**PARK CITY MUNICIPAL CORPORATION
PLANNING DEPARTMENT ADMINISTRATIVE PUBLIC HEARING MINUTES
PLANNING DEPARTMENT CONFERENCE ROOM
MARSAC MUNICIPAL BUILDING
JUNE 18, 2026**

- D. 301 Marsac Avenue – Historic District Design Review –** The Applicant Proposes Constructing a New Single-Family Dwelling on a Non-Historic Site in the Historic Residential - 1 Zoning District. PL-23-05944.

16. This HDDR approval is pending recordation of the 301 Marsac Plat Amendment with the Summit County Recorder by August 12, 2026.
- E. 405 Woodside Avenue – Historic District Design Review –** The Applicant Proposes a Remodel and Rear Addition to a Single-Family Dwelling at a Significant Historic Site in the Historic Residential – 1 Zoning District. PL-25-06510.

Building Height – maximum 27 feet above Existing Grade.

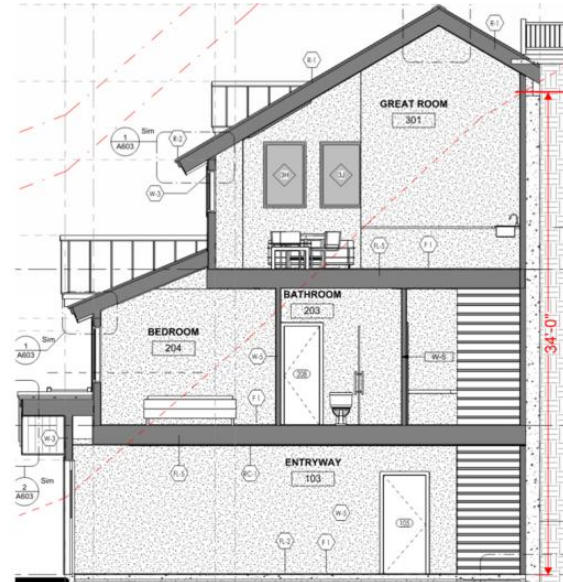
Complies: The proposed Structure does not exceed 27 feet above Existing Grade.

Maximum interior height of 35 feet, measured from the lowest finish floor plane to the point of the highest wall top plate that supports the ceiling joists or roof rafters.

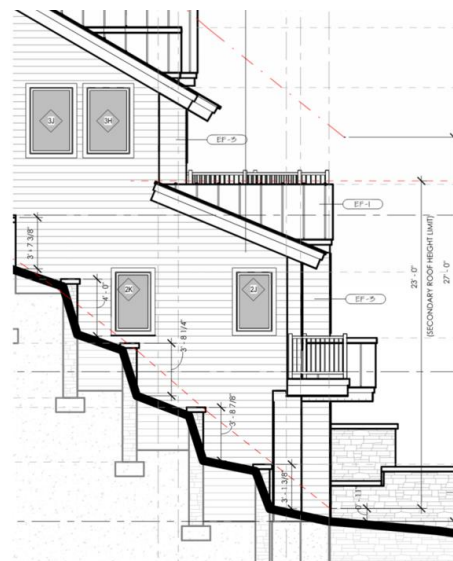
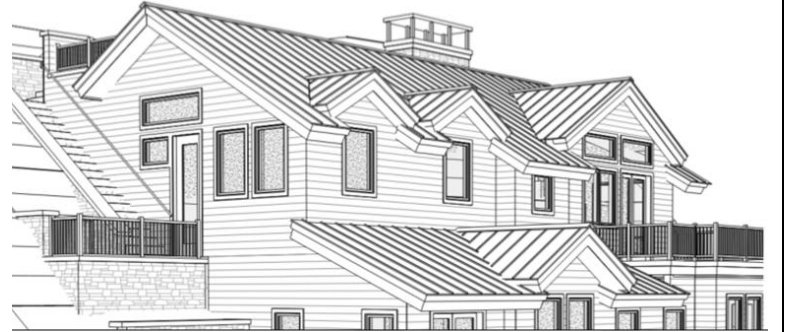
Complies: The proposed Structure is 34 feet in height at its highest point, measured from lowest finish floor plane to the point of the top of the wall plate that supports the ceiling joists or roof rafters.

Complies: The Structure steps back 10 feet at 23 feet on the east side, on the downhill portion of the Lot.
